East Anglia ONE North and East Anglia TWO Offshore Windfarms

Onshore Substations Update Clarification Note

Document Reference: ExA.AS-11.D3.V1

Plate 5.2: 3D model of the updated easternmost onshore substation showing reduced footprint and building / equipment parameters

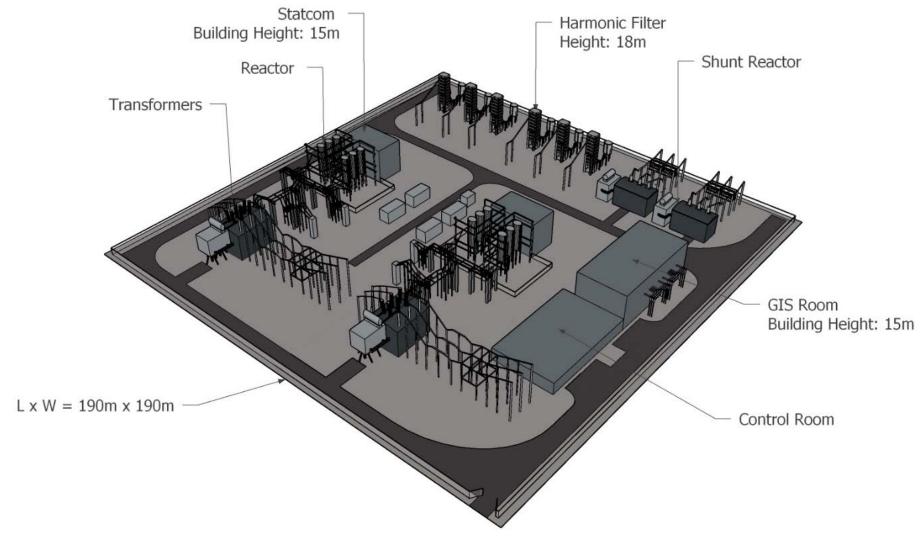
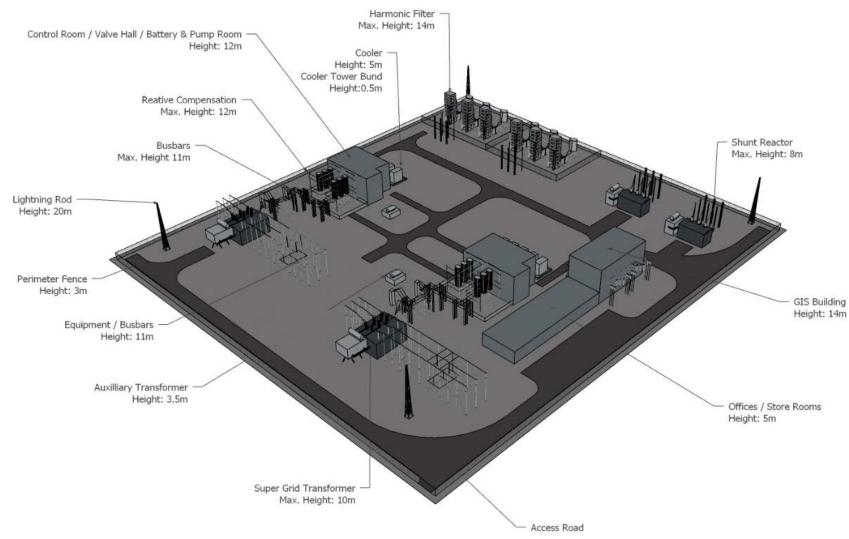
- 26. The combination of reduced footprints and lowered ground levels has necessitated a minor rearrangement of the onshore substation layout. *Plate 5.1* and *Plate 5.2* provide a comparison of the 3D model used with the Applications and that based on the updates presented in this clarification note.
- 27. As noted, the Applicants have provided a selection of updated photomontages based on the revised finished ground levels in the *Updated Photomontages Clarification Note* (document reference ExA.AS-16.D3.V1); these are based on the 3D model presented as *Plate 5.2*. More detail, including any required assessment updates, will be submitted to the Examinations at Deadline 4.
